66309D-521-03

S E R V I C E N O T E

66309D with Option #521

Reliability Improvement of Instrument

CORRECT J207 PLACEMENT – alignment to within $< 0.3\text{mm}$

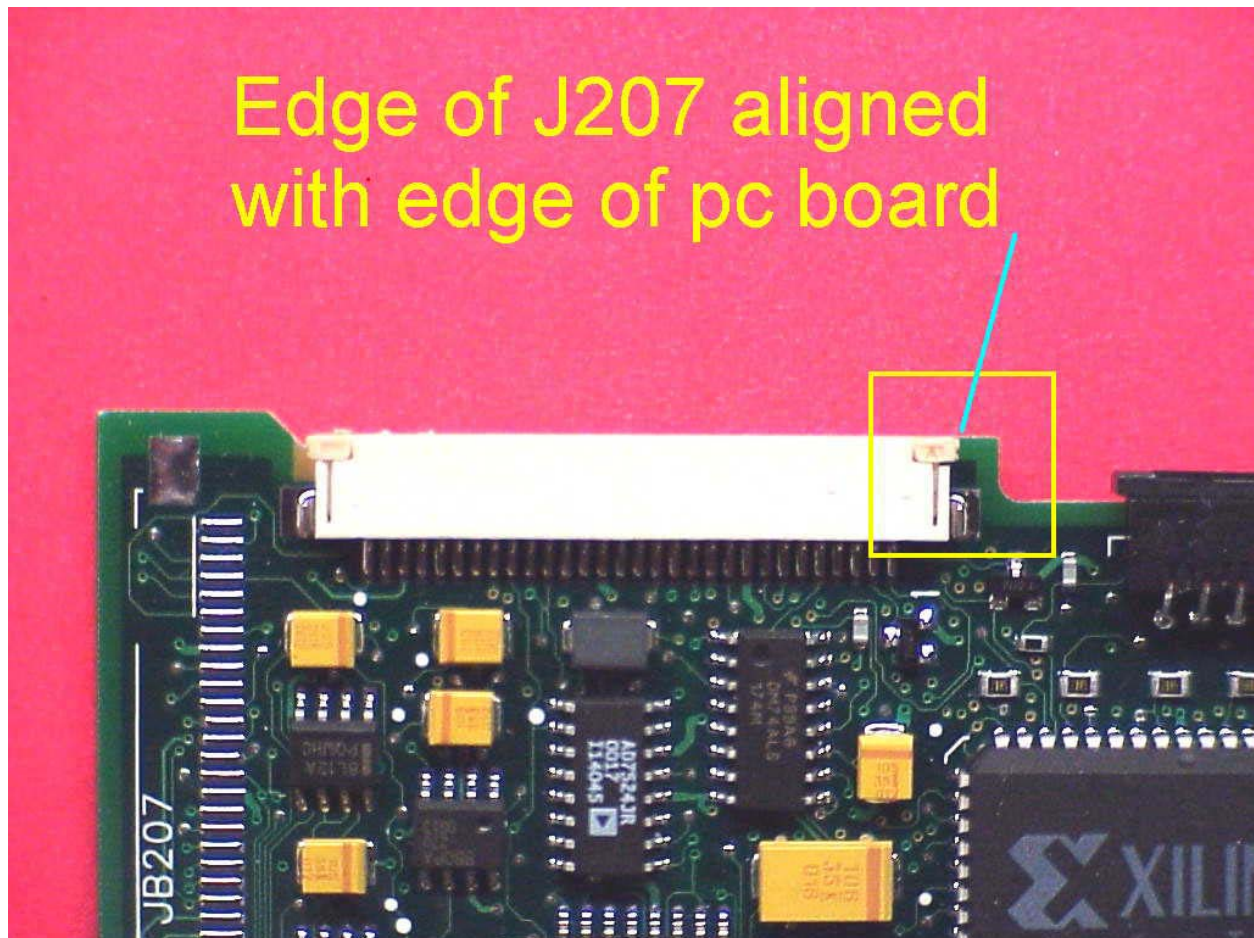
Latent product failure due to misplaced connector J207 on SMT assembly 5064-0018 (GPIB/RS232 interface). Misplacement of J207 could lead to inadvertent contact/shorting of exposed feed-throughs on SMT board. Ultimately, resulting in over-stress of components of damage to SMT board components. Resulting contact could degrade useful life of instrument.

Picture shows connector aligned to edge of SMT board to within $< 0.1\text{mm}$

- 1) Compare placement of J207 to attached photos. Instruments with a “misplaced” J207 should be returned to Agilent for warranty repair.
- 2) Instruments returned to the Service Center for routine calibration should be inspected for this potential defect. Defects should be addressed using Agilent’s unit exchange process with costs being charged to warranty.
- 3) The factory has modified production documentation to include visual inspection and specific electrical testing for this potential short.
- 4) Factory is maintaining feedback to SMT board supplier regarding quality of assembly.

INCORRECT J207 PLACEMENT – misaligned by $> 0.3\text{mm}$

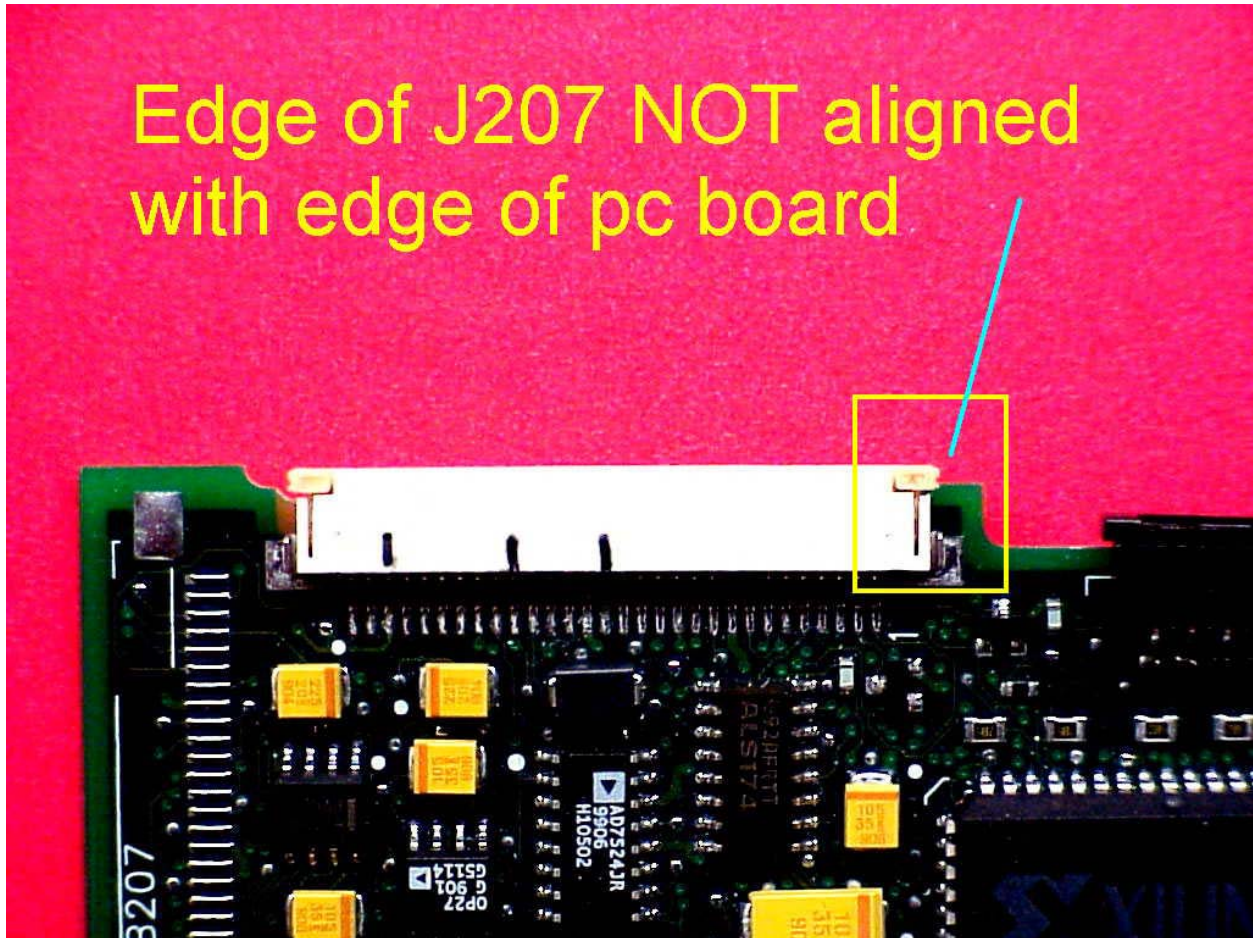
Picture shows connector extending past edge of SMT board by $>1.2\text{mm}$
